WATER CONTROL MANUAL

PRADO DAM & RESERVOIR SANTA ANA RIVER, CALIFORNIA

SEPTEMBER 1994

CESPD-ED-W (CESPD-ED-W/8 Jan 92) 3rd End WINGERD/272-8510
SUBJECT: Updating Prado Dam and Reservoir Water Control Manual

HISTORICAL RAINFALL

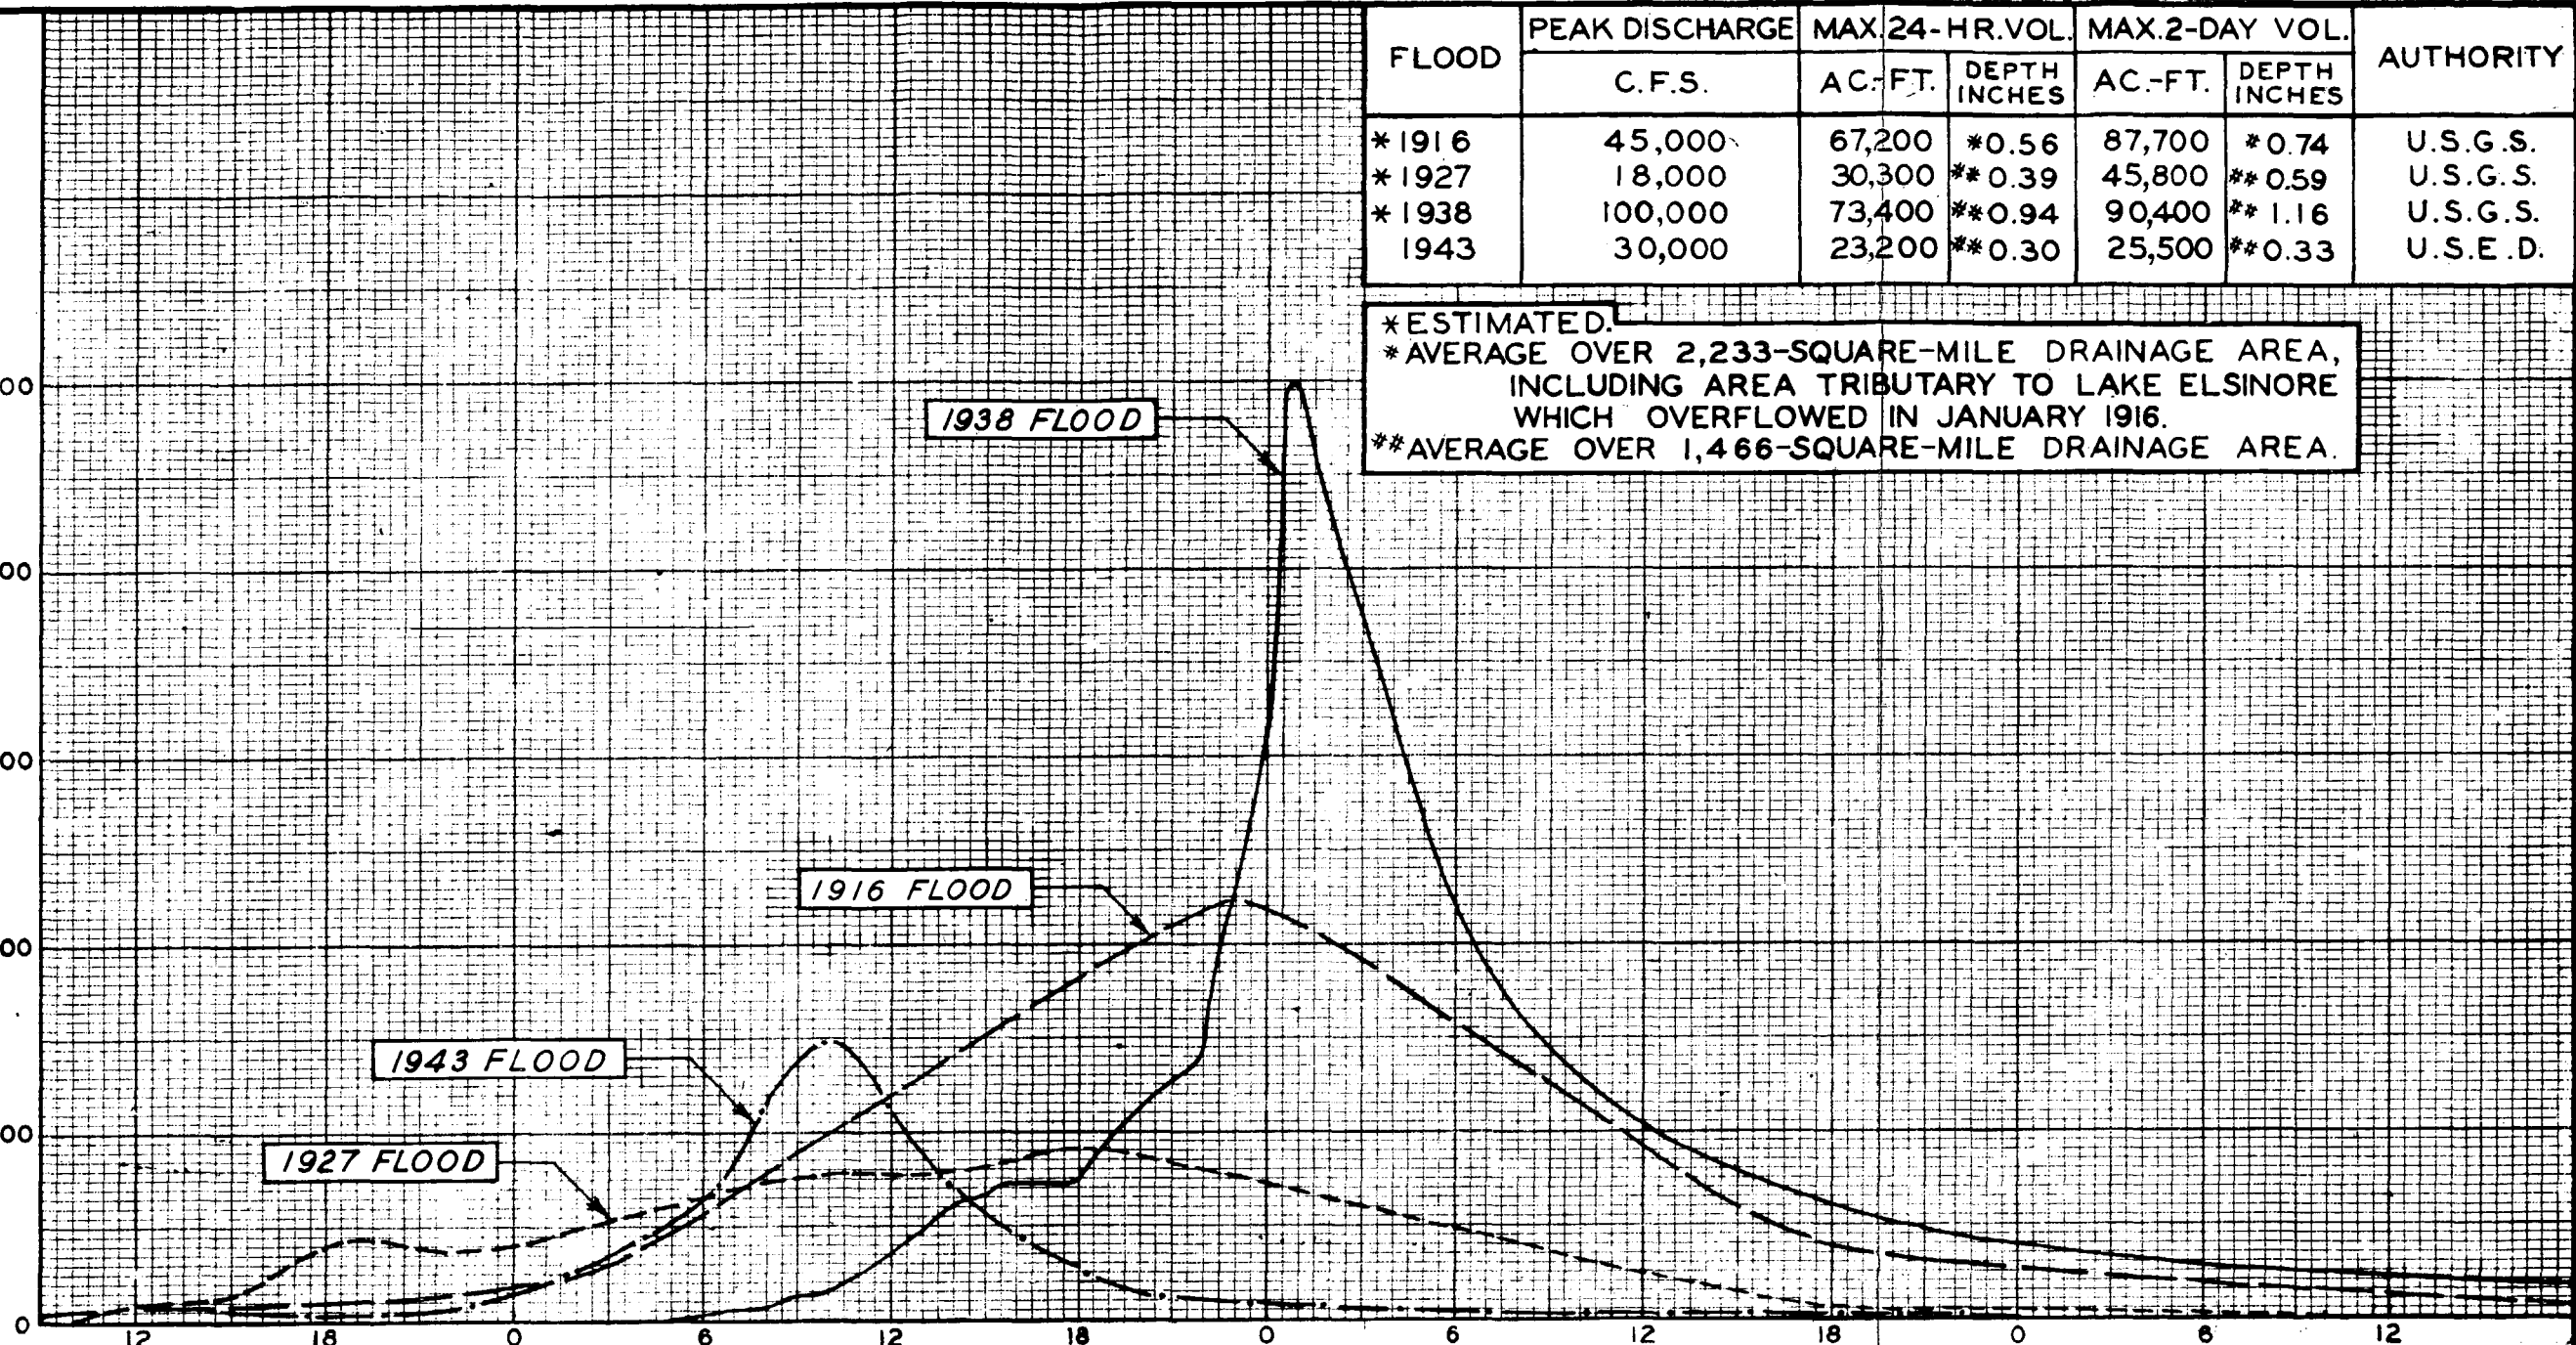
6. Plate 4-07- Extend data through Water Year 1989 or to the last data available. (CESPD-ED-W)
7. Plate 4-08- Revise symbols to make chart easier to read. The estimated values should be by the flows instead of the year of the flood. (CESPD-ED-W)

6. Concur. Precipitation data for plate 4-07 has been extended through fiscal year 1989.
7. Do not Concur. The base plate for plate 4-08 has not been revised because the original is from an older report and is not readily revised.

PLATE 8-05b

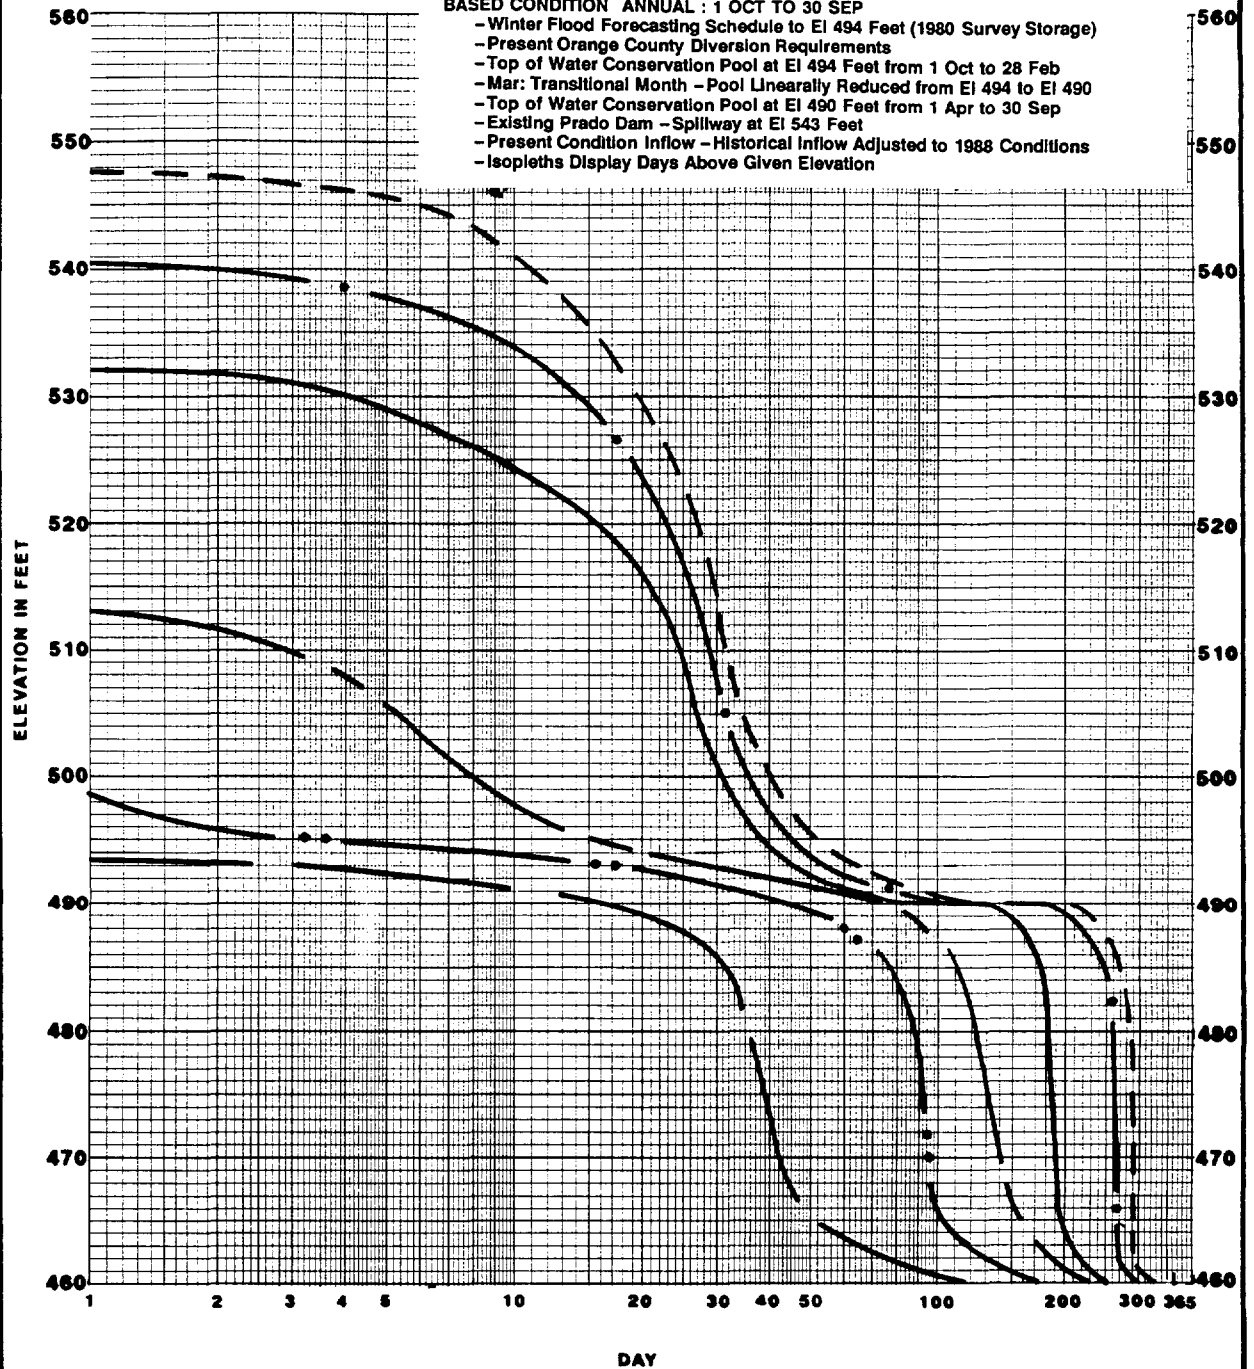
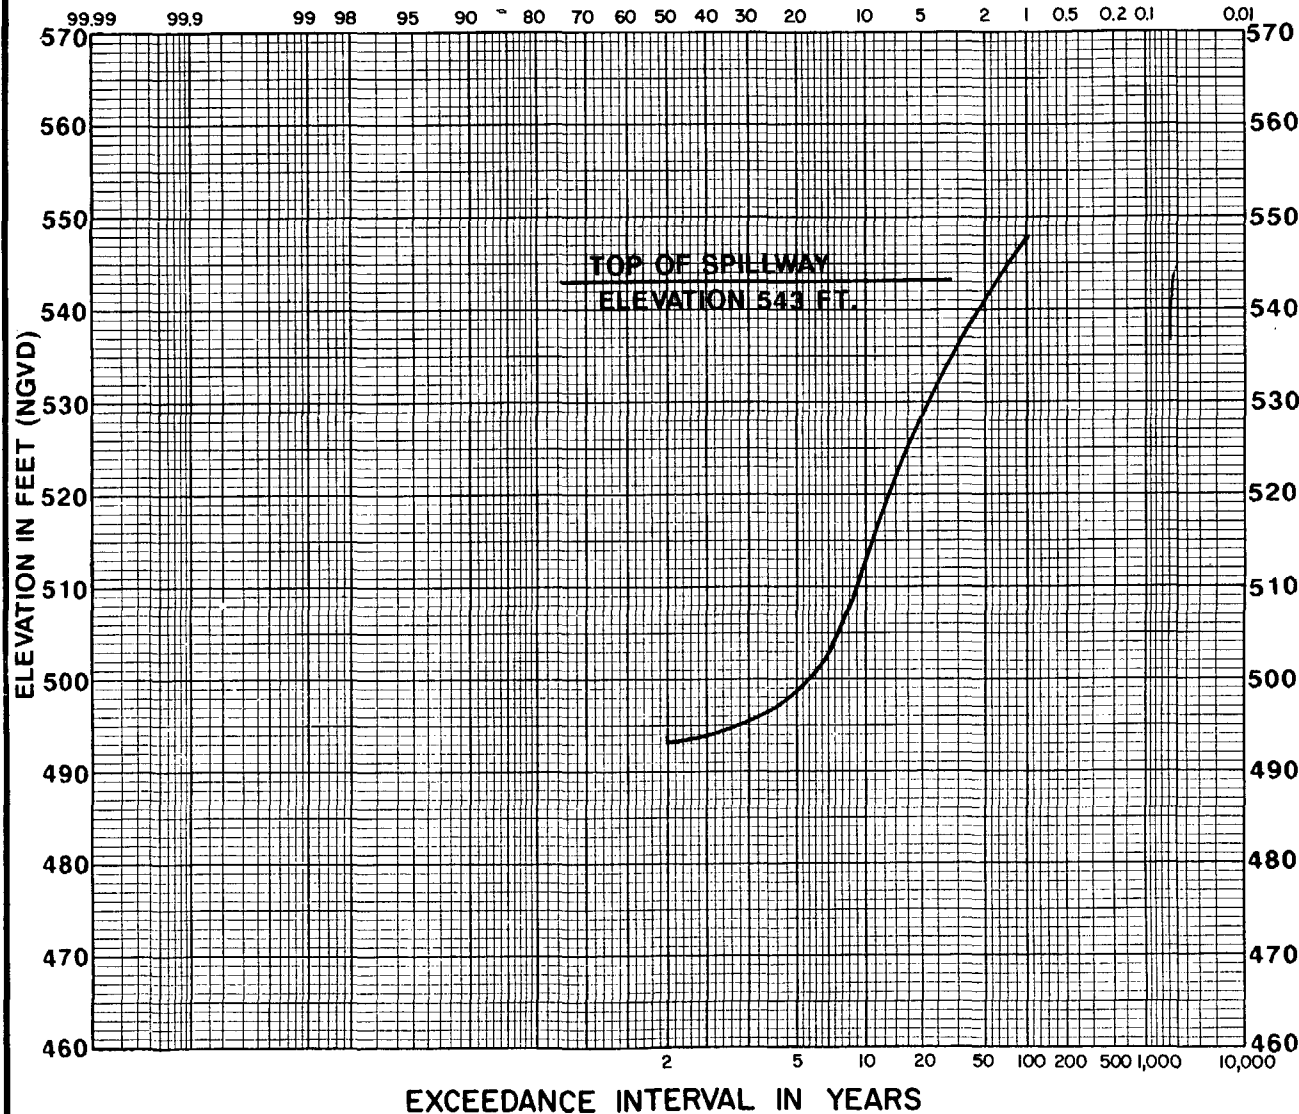
9. Provide the difference in plates 8-05a and 8-05b as both title boxes appear the same. (CESPD-ED-W)
10. Appendices C, D and E contain the methodologies for forecasting reservoir inflows, recession inflows and buffer pool releases. These are based on algorithms determined from historical storms and rely on forecasted amounts of precipitation. District should indicate in the appendices the source of this data. In addition, all forecasted data and resultant inflows and outflows should be presented and stored on the District's WCDS. (CESPD-ED-W)
